ECE/TRANS/WP.29/GRSP/2009/16
23 September 2009

PROPOSAL FOR THE 01 SERIES OF AMENDMENTS TO REGULATION No. 100
(Construction and functional safety of battery electric vehicles)

Submitted by the Chairman of the Informal Group on Electric Safety */

Figure 1: Measurement of V_b , V_1 , V_2

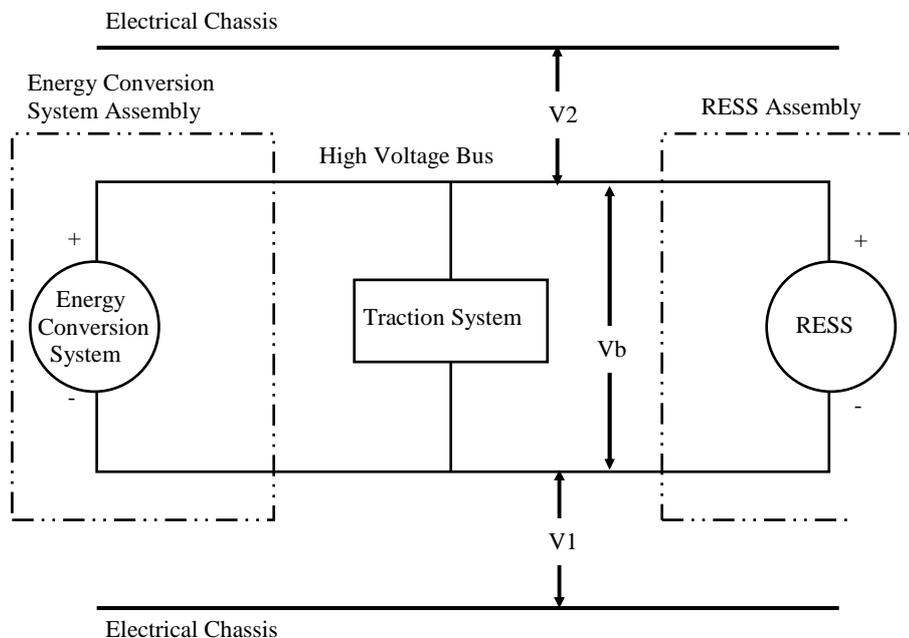
The voltage is measured as shown in Figure 1 and the high voltage Bus voltage (V_b) is recorded. V_b shall be equal to or greater than the nominal operating voltage of the RESS and/or energy conversion system as specified by the vehicle manufacturer.

Measure and record the voltage (V1) between the negative side of the high voltage bus and the electrical chassis (see Figure 1):

Measure and record the voltage (V2) between the positive side of the high voltage bus and the electrical chassis (see Figure 1):

Figure 2: Measurement of V1'

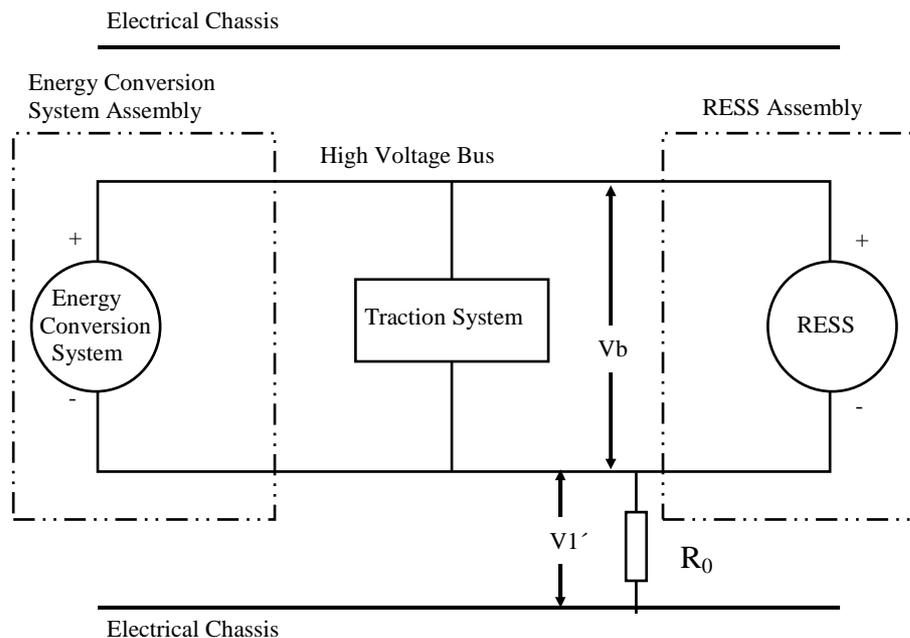
If V1 is greater than or equal to V2, insert a standard known resistance (Ro) between the negative side of the high voltage bus and the electrical chassis. With Ro installed, measure the voltage (V1') between the negative side of the high voltage bus and the electrical chassis (see Figure 2).

$$R_i = R_o * (V_b / V_1' - V_b / V_1) \quad \text{or} \quad R_i = R_o * V_b * (1 / V_1' - 1 / V_1)$$

Figure 3: Measurement of V_2'

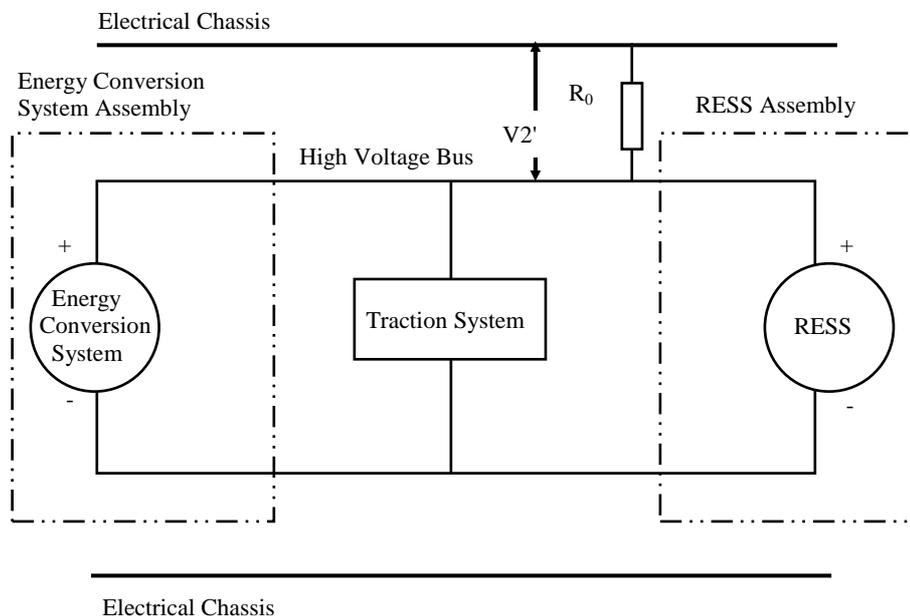
If V2 is greater than V1, insert a standard known resistance (Ro) between the positive side of the high voltage bus and the electrical chassis. With Ro installed, measure the voltage (V2') between the positive side of the high voltage bus and the electrical chassis. (See Figure 3). Calculate the electrical isolation (Ri) according to the formula shown. Divide this electrical isolation value (in ohms) by the nominal operating voltage of the high voltage bus (in volts).

$$R_i = R_o * (V_b / V_2' - V_b / V_2) \quad \text{or} \quad R_i = R_o * V_b * (1 / V_2' - 1 / V_2)$$

~~MEASUREMENT OF THE INSULATION RESISTANCE USING THE TRACTION BATTERY~~

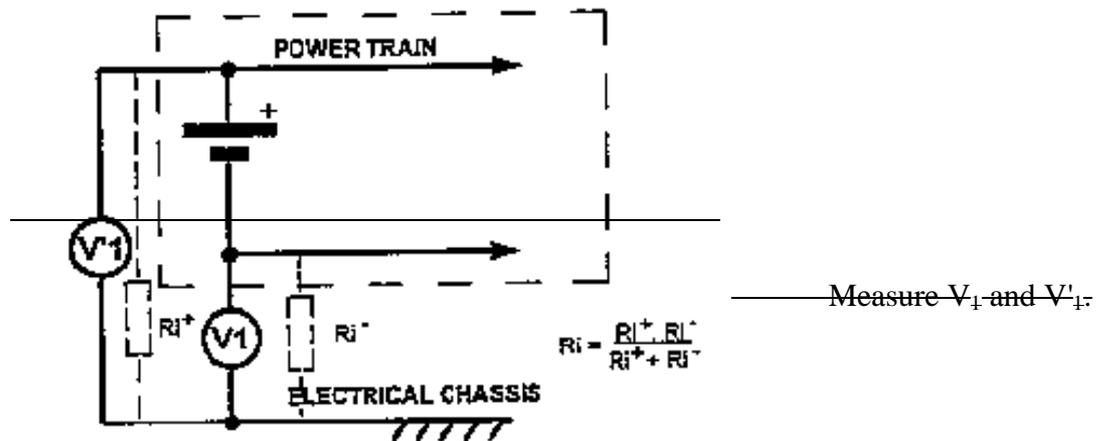
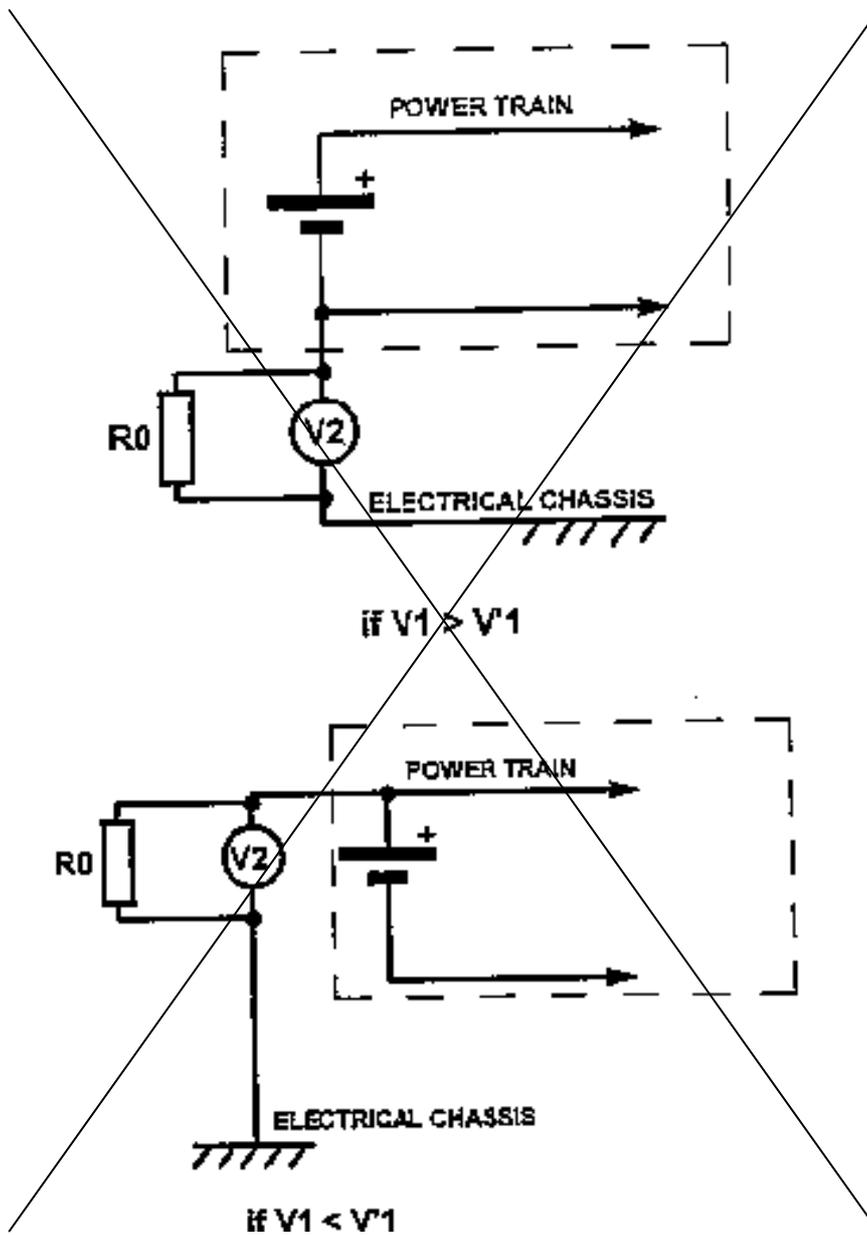
~~1. DESCRIPTION OF THE TEST METHOD~~

~~The traction battery shall be fully charged~~

where R_0 is a resistance of 500 S/V
